Addendum No. 1
Date: January 30, 2026

**Addition to
Andalusia Elementary School for the
Andalusia City Schools
Andalusia, Alabama**

MCKEE PROJECT NO. 24-304

ALABAMA DIVISION OF CONSTRUCTION MANAGEMENT NO. 2025681

SHEET TITLE
FOUNDATION PLAN PART "A"

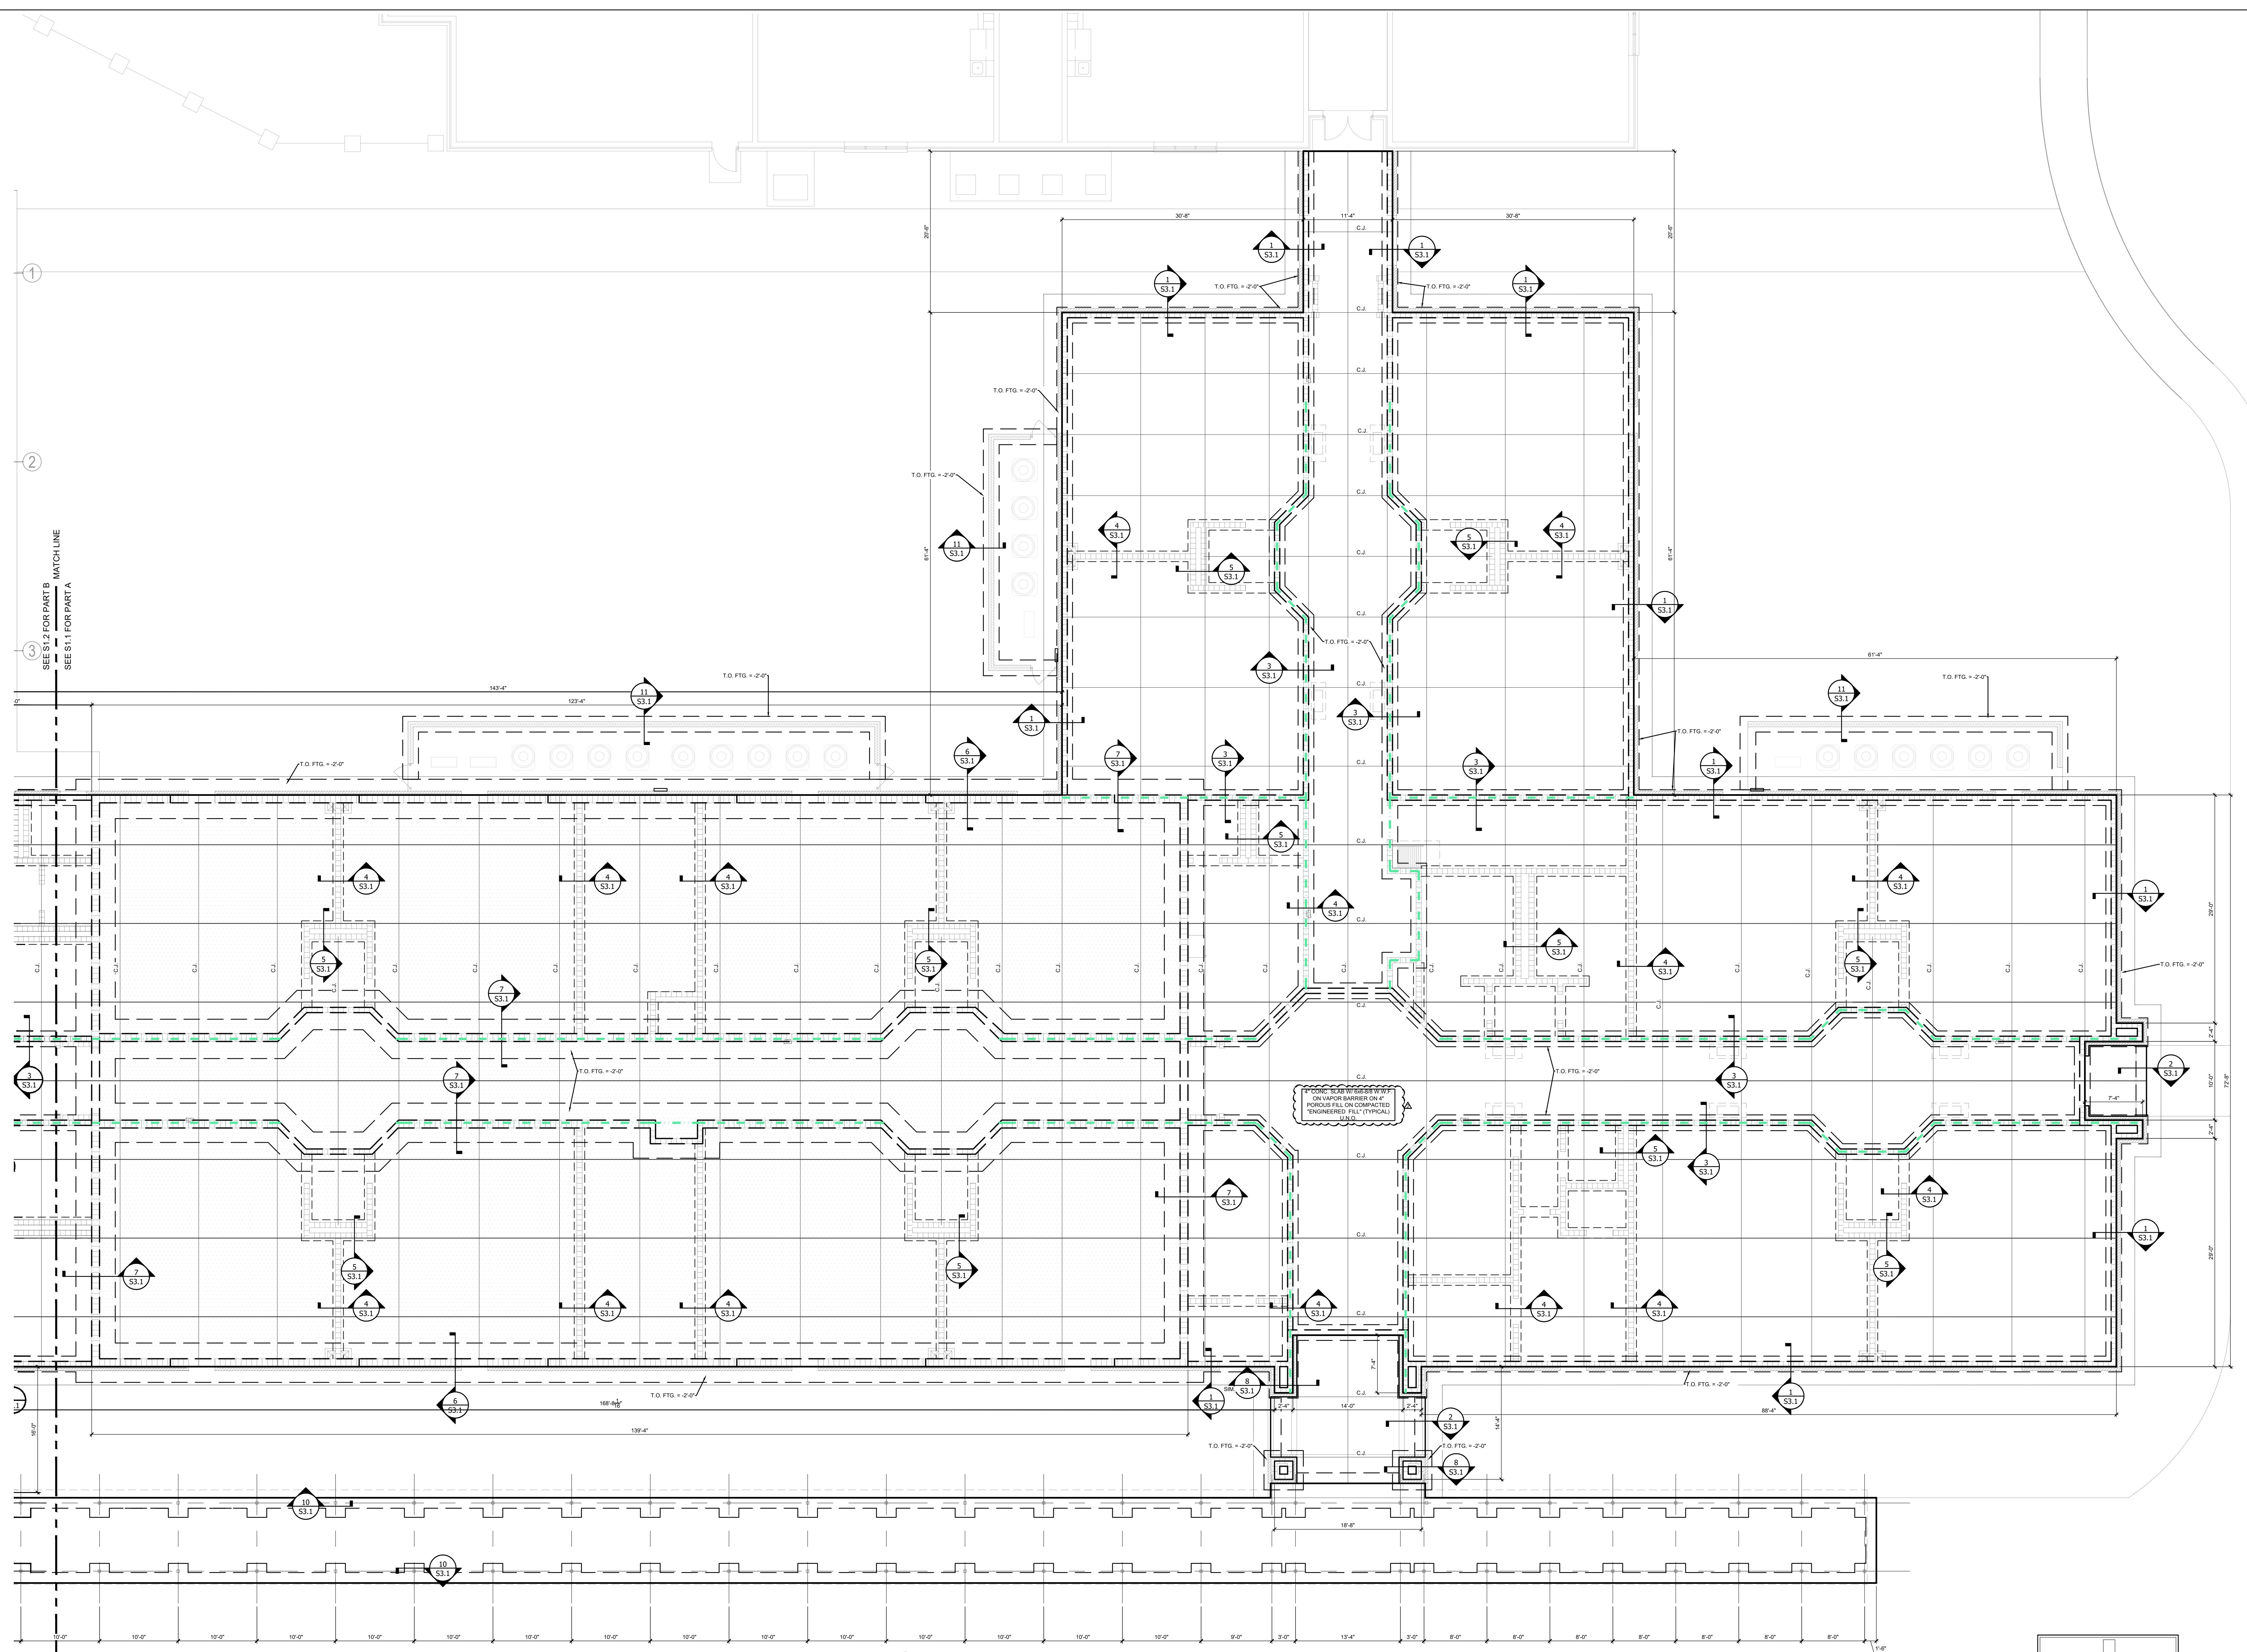
- A. See the attached Revised Drawings as follows:
 - 1. S1.1, and S1.2 (**Revised 1.28.26**), herein.
 - 2. A4.1 (**Revised 1.30.26**), herein.
 - 3. E0.3 (**Revised 1.30.26**), herein.
 - 4. E1.1 (**Revised 1.29.26**), herein.
